MINUTES OF HORSMONDEN PARISH COUNCIL

PLANNING COMMITTEE MEETING

ON TUESDAY, 20 FEBRUARY 2024 AT 7:00PM

Planning Application:	24/00078/HYBRID
Proposal:	<u>Hybrid application: Full application for the erection of 120 No. dwellings (Use Class C3), including affordable housing, landscaping, public open space, allotments, ecological enhancements, SUDs and access. Outline application (with all matters reserved) for 0.25 hectares of land for a new Medical Centre (Use Class E(e)) with associated access, parking and</u>

Figure 1: Map showing the adopted Limits to Built Development (source: HNP, 2023)

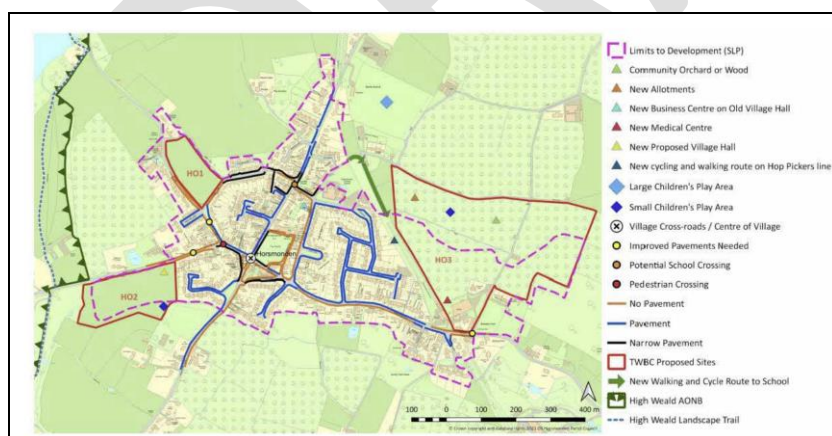
- 1.9. This statement is not wholly accurate. The site is not wholly included within the adopted LBD for Horsmonden. Rather it extends significantly north of the adopted LBD, particularly on the western part of the site.

- 1.10. The adopted LBD is not indicative, as is often referenced by the applicant. It has in fact been established in the HNP, as shown on *Figure 1* (the dotted pink line). It duplicates the LBD as shown in the TWBC SLP, which was informed by a series of evidence reports (see para 1.10) and has been adopted via the HNP in advance of the adoption of the SLP.

Figure 3: Extract from the National Landscape (AONB) (source: AONB Setting Analysis Report, 2020)

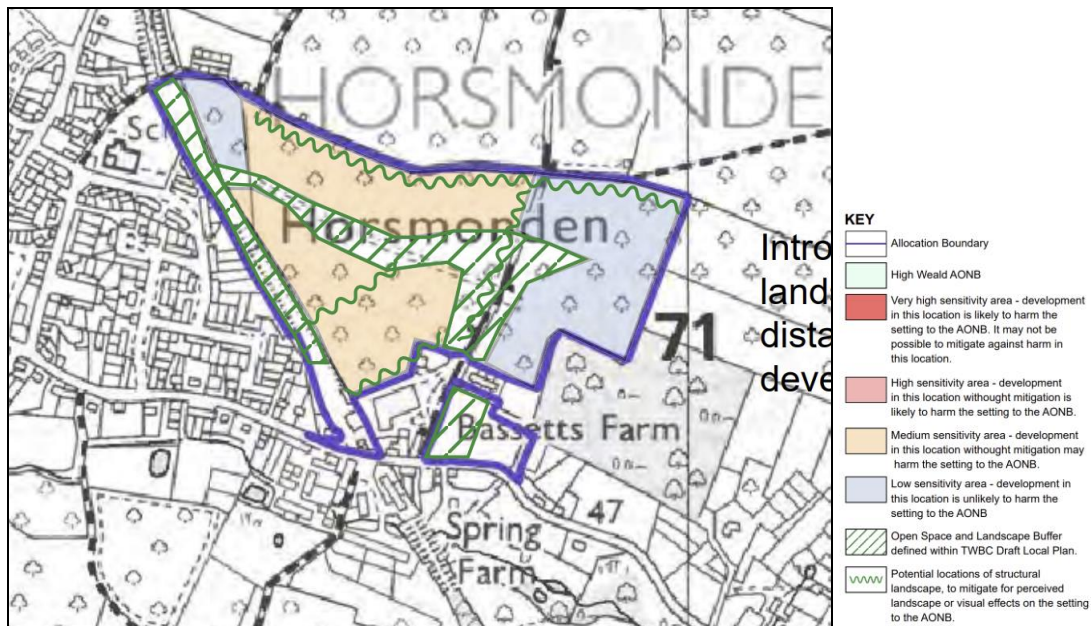
- [AONB Setting Analysis Report: supporting plans and photographs](#) (2020) – The northern areas of the proposed site allocation are considered to have medium sensitivity, meaning that development in this location without mitigation may harm the National Landscape (formally referred to at the AONB). The landscape buffer is shown on these maps (*Figure 3*).

Figure 5: Site allocation map for AL/HO3 (SLP)

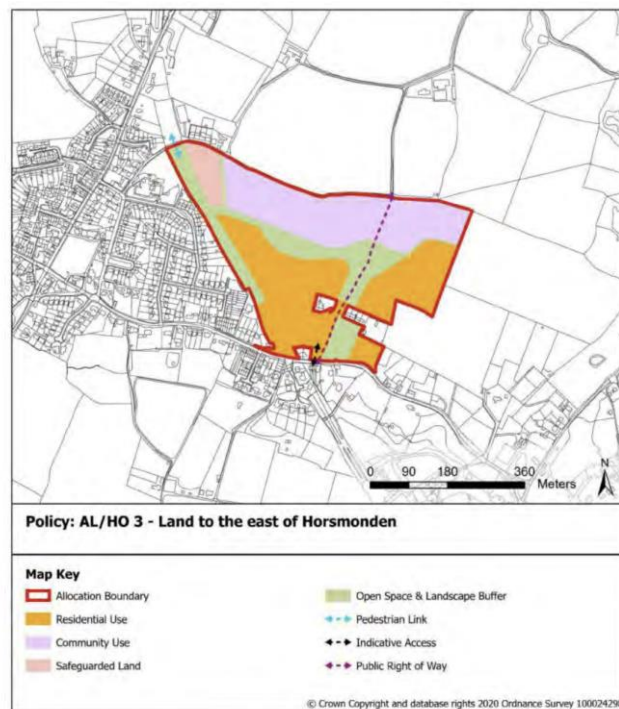
- 2.17. The location of the health centre was discussed at the [Local Plan Examination hearing session for Horsmonden](#) (that can be accessed from 2hrs:35mins) on 5 July 2022. Officers confirmed that its precise location was not finalised and that this would be done through the masterplanning of the site as part of the planning application process. The Inspector agreed with this approach, however, he advised that Policy AL/HO3 should be modified to state that the medical centre will be delivered within

the orange Residential Use area, as shown on the site allocation map (Figure 5) and not within the purple Community Use area.

Figure 10: Image showing area (within the oval area) where landscape buffer should be placed (left), as per SLP site allocation policy (right)

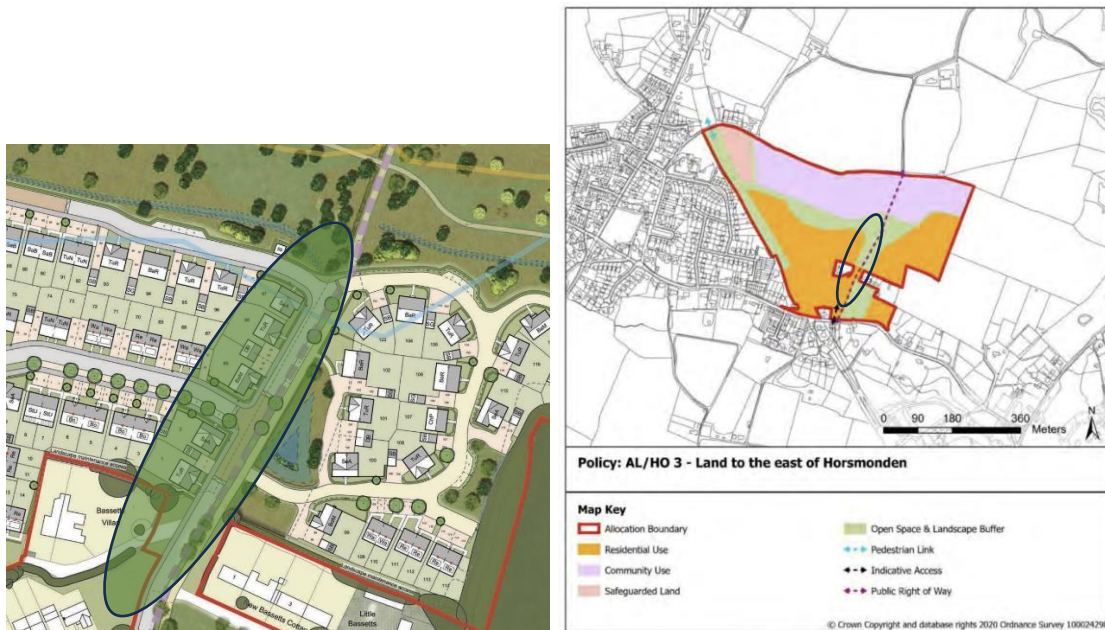
5.10. From a heritage perspective, the proposal seeks to site eight dwellings to the west of the footpath located to the east of Bassetts Villas, which are non-designated heritage assets. This is not in accordance with the site allocation policy in the SLP, which requires a landscape buffer in this location, to the west of the footpath. This is shown on *Figure 10*. The plans should be amended to incorporate this buffer, which would assist in preserving the setting of those heritage assets.
